MINUTES

Montevallo City Council Special Session

November 30, 2020

Case No. SD20-008 – Lexington Parc, Amended Master Plan

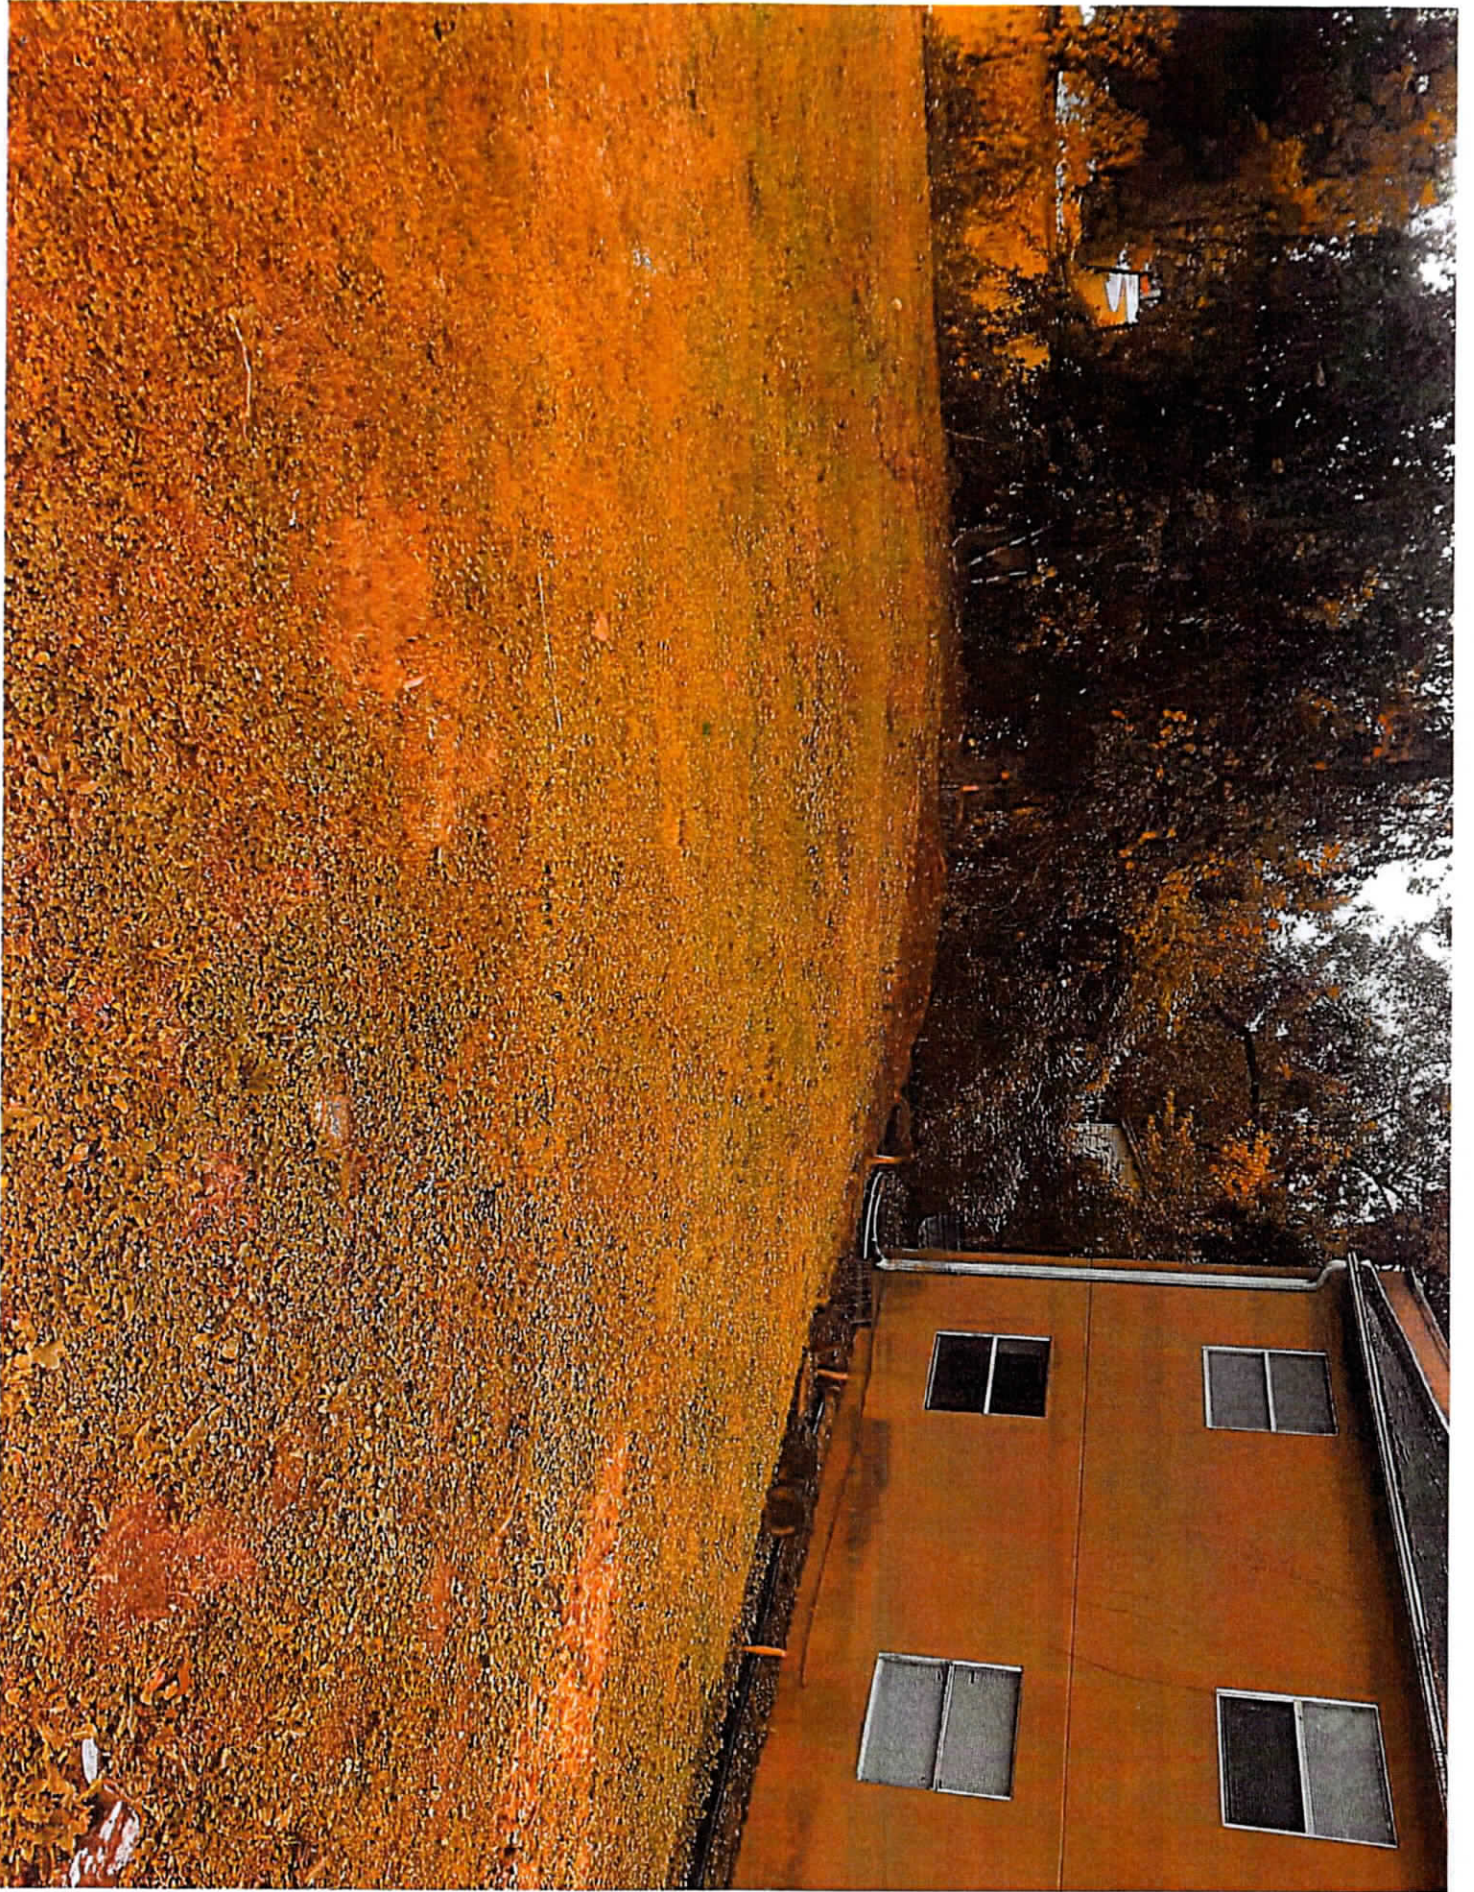
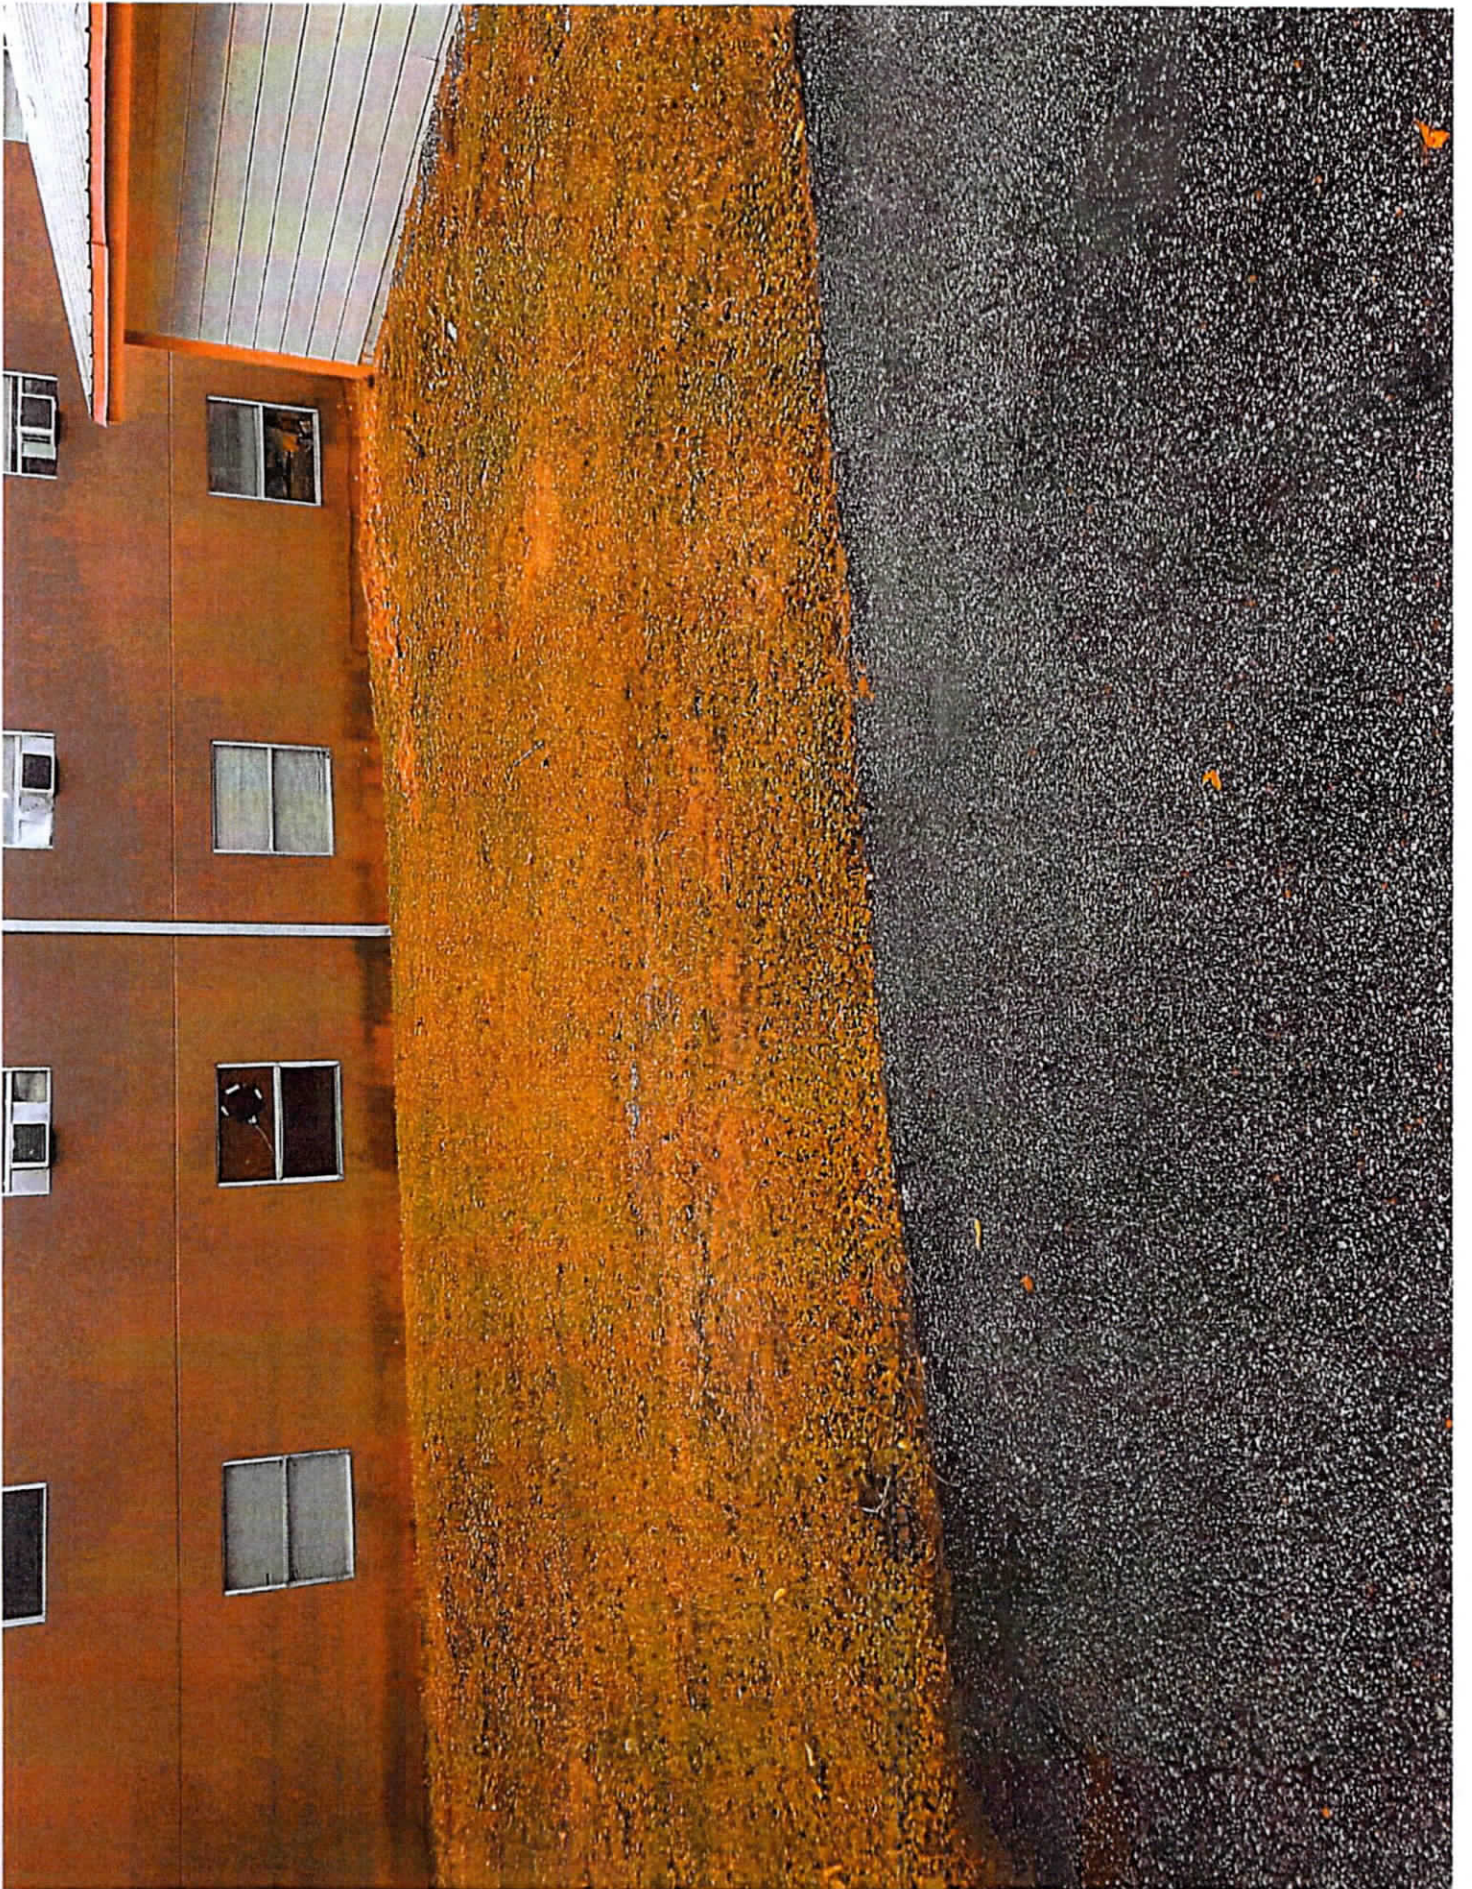
See Photos attached: In the past I have had a few flooding issues with the runoff from the stated property into my apartments with the once a decade storms of 6"-8" rains in a day. I have had to build a directing runoff Berm to take the runoff from such storms around my building towards the south and towards Orr Park and the field next to these properties. It seems to work fairly well. But, with the additional parking paving and sidewalk construction that is pushing the boundary towards the bank and drainage ditch I worry that it may increase the storm runoff to the ditch and into my apartments.

The easy solution I am suggesting and am sure Mister Jimenez will receive is to push the soil to create a small Berm or pour a solid curb to the additional parking on the West/South of his building to direct storm water runoff towards the south and into the field adjoining and not towards my apartments. The cost of this will be really absolute 0\$ dollars except for the preparation of the soil and grass area for the concrete pour or paving for a berm. I do not have a contact for Mister Jimenez, so if you could convey this to him before or during the hearing on Monday I would greatly appreciate it or if you could share his contact with me so I could confer myself. Please tell him I come in peace (as always) but would appreciate his consideration in this matter, Thank you so very much.

Councilman Dukes asked about drainage issues raised from adjoining property owner Mark Robinson. City Engineer Matthew Burgess stated that the presented site plan did not make any changes to the grading of the property and would not change the current drainage. City Clerk Steve Gilbert called council's attention to the letter and photographs received via email from the adjoining property owner Mark Robinson.

The drainage issue in question has existed during times of heavy rain and it was recommended that the property owners discuss a way to help reduce the flow of water during heavy rains (i.e. planting of shrubs or a natural area) in lieu of altering the submitted plan or making changes to the grading.

Proposed Site Development

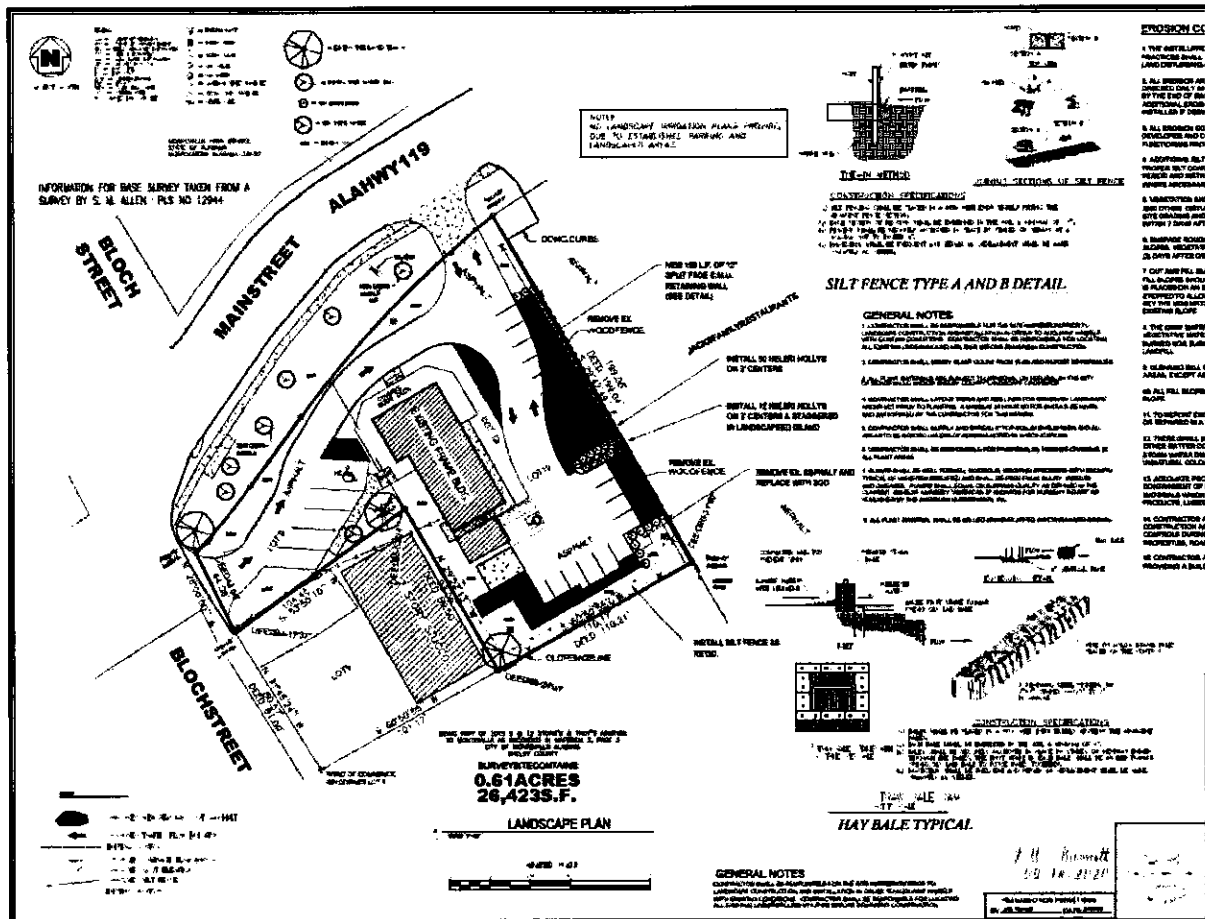
The previous business did not maintain striped parking spaces on site. Generally, the site could park approximately 25 vehicles as determined by aerial photography review. The existing building is approximately 2,698 square feet. Restaurants require a parking ratio of one space per 100 square feet of floor area. A total of 27 parking spaces are required per the regulations and 27 parking spaces are provided on the site plan, including two ADA handicap spaces with one van accessible space. The site data table on the plan set incorrectly identifies 26 parking stalls and incorrectly identifies the parking calculation. This was also identified in the City Engineer’s comments and must be corrected prior to site plan certification.

1. The site Data Table on the cover sheet still does not outline all applicable impervious surfaces as to match Sheet C-2.
2. Reference is made to “Retail” parking and its associated floor space requirements; the proposed land use is “Restaurant”. Please update the parking standard with the correct use and required off street parking equation as outlined in the city of Montevillo Zoning Ordinance. Prior to final certification of the site development plan the following items must be added to the plan set.

A revised site plan was submitted for review on October 20, 2020. The revised plans addressed all outstanding comments from the City Engineer and the Water and Sewer Board. The revised plans also included replacing an existing chain link fence, at the rear property line and abutting a residential lot, with a six-foot wooden fence. The DRC reviewed the proposed additional screening plan on November 3, 2020 and approved the addition of the six-foot wooden fence for additional screening. No additional plantings were recommended by the DRC. The Arbor and Beautification Board reviewed and approved the proposed landscaping plans dated September 16, 2020. The addition of the wooden fence does not alter the previously reviewed and approved landscaping.
